**FOUR COUNTY SC LIDAR  
QUALITY ASSURANCE  
PICKENS COUNTY REVIEW**

UNITED STATES GEOLOGIC SURVEY  
AND  
SOUTH CAROLINA DEPARTMENT OF NATURAL  
RESOURCES

USGS CONTRACT: G10PC00025  
TASK ORDER G11PD01086

First review: October 15, 2011  
Second review: February 17, 2012

**Figure 2: Overall project flightline exhibit (left) and enlarged view (right)**

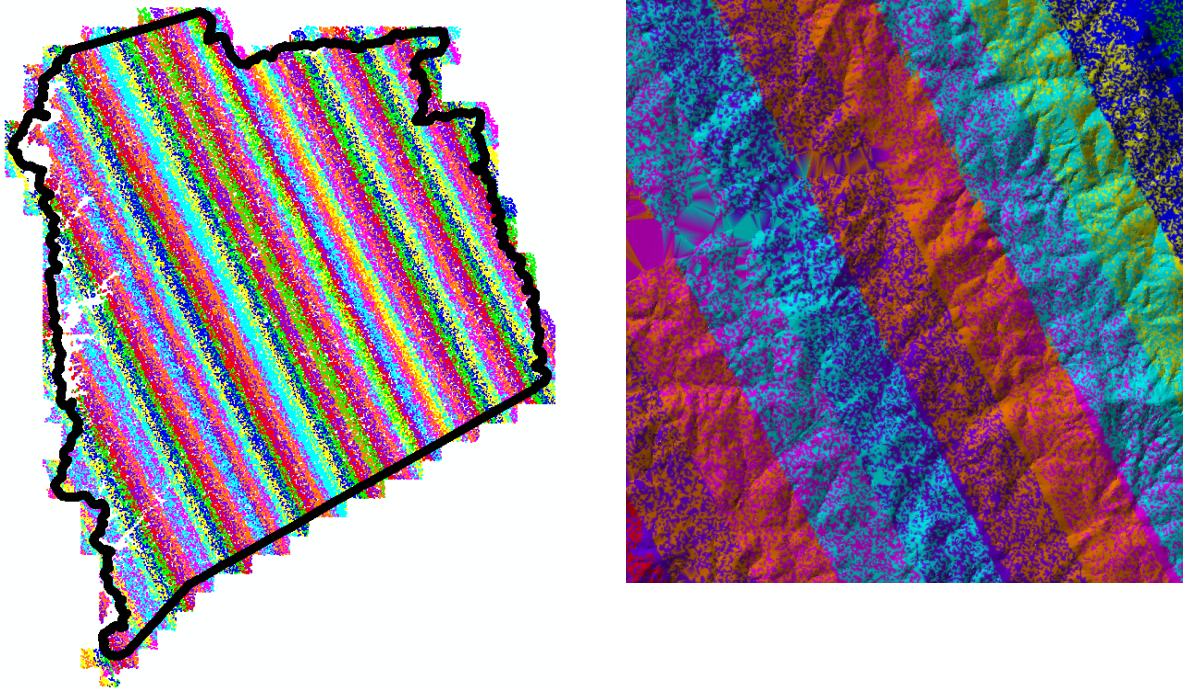
The first item outlined in the Criteria states that flightlines are directed to be flown as planned with 10% minimum sidelap between flight lines. The flightlines were flown with a sidelap of 45 to 50%. The collected data couldn't have holidays and needed to have periodic and local calibration checks. No holidays were noted in the review of 10% of the project area. The exhibits below show the extents of sidelap:

**Figure 3: York County Checkpoints**

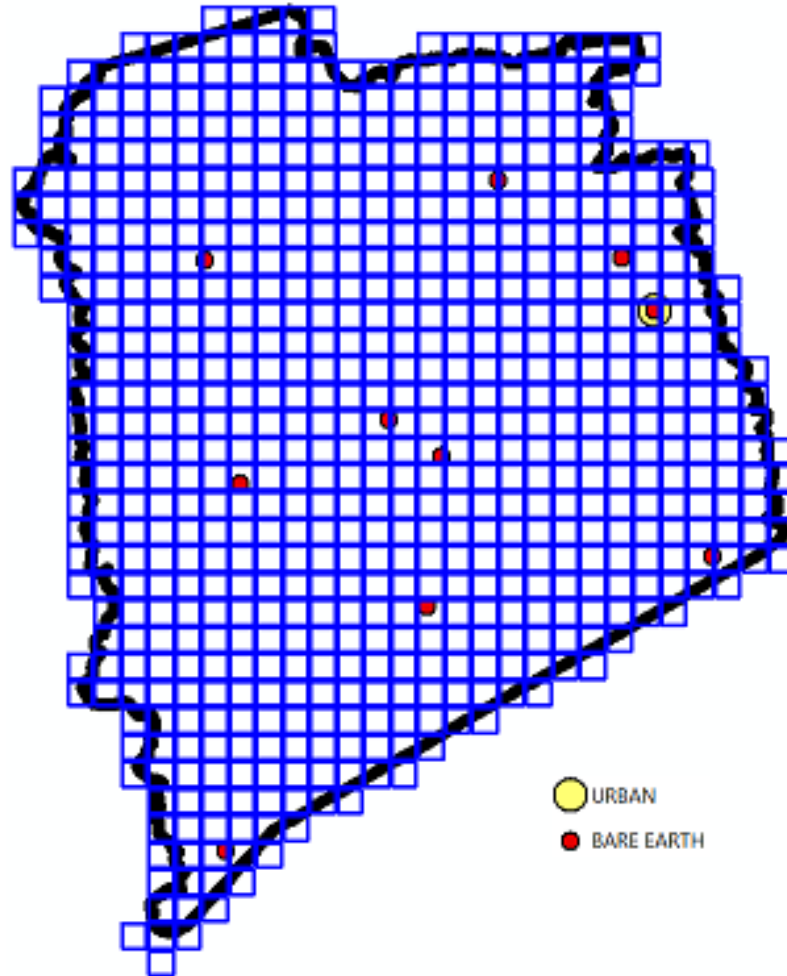
The Criteria also requires GPS baseline lengths to be less than 25 miles. The GPS baseline lengths are established by the distance between check points. Eleven check points were collected for the Pickens County data collection – ten points are classified as bare earth and one is classified as urban. The figure below shows the location of said checkpoints in relation to Pickens County and the provided tiles.

**Figure 4: Forward vs. Reverse Post-Processed Solution – Lift 071B**

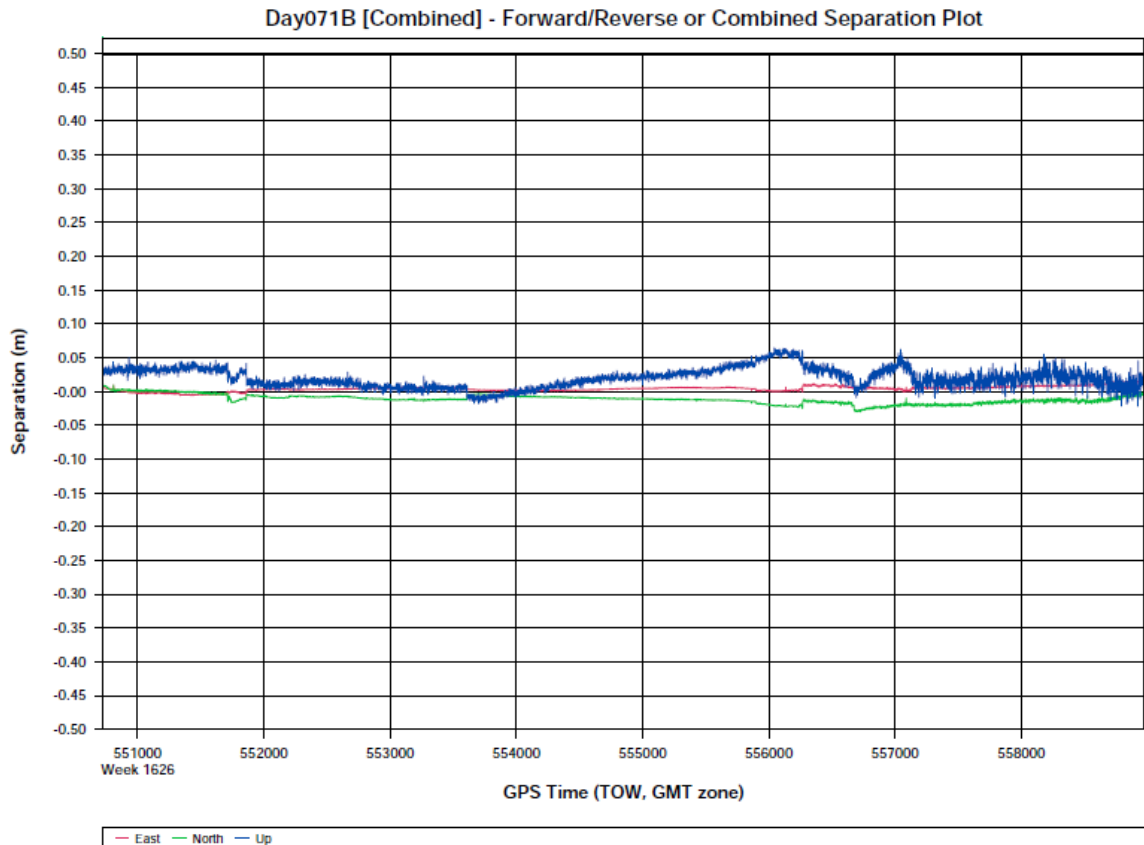
Additionally, the Criteria requires the GPS trajectories to be evaluated with forward and reverse comparisons within 10-20 cm. The GPS solution chart below, as provided by Dewberry, shows forward and reverse comparisons within 3 - 6 cm.
